Mr. Depillis, in his prefiled testimony, has requested the Commission require that the stockpile be placed on slopes less than 15% as a condition of issuing a CPG.

**PAS Stockpile as seen on Site Plans 1 and 2.
Minor contours are 1 ft.**

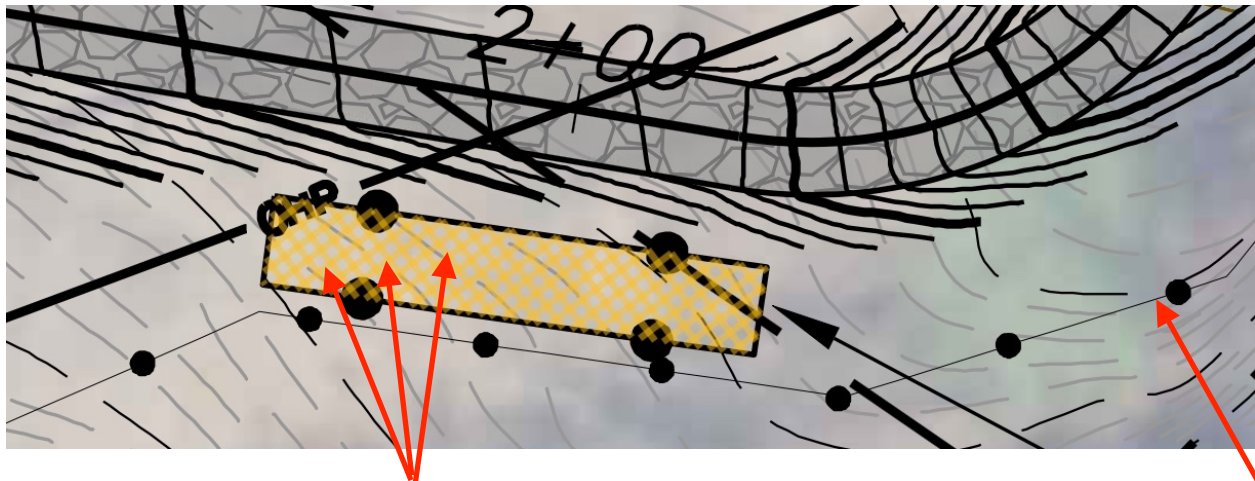
The western half of the stockpile is on slopes greater than 15%, and the southwest corner of the stockpile is on greater than 25% slope.

1 ft. Contour lines reveal that the PAS Stockpile is on greater than 15% slope

**PAS Stockpile as seen on Site Plans 4, 5, and 6.
Minor contours are 2 ft. Slopes greater than 25% are Green.**

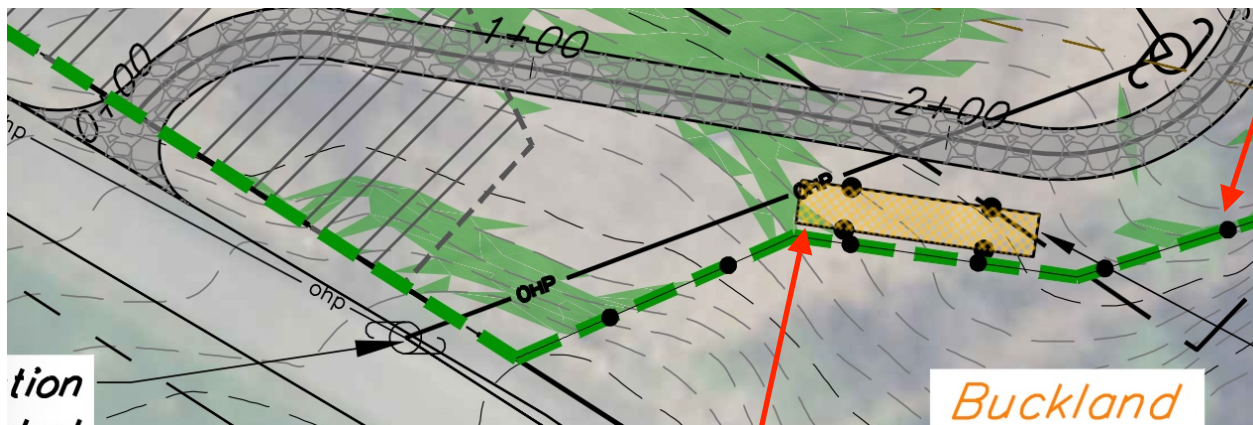
Corner of PAS Stockpile on greater than 25% slope
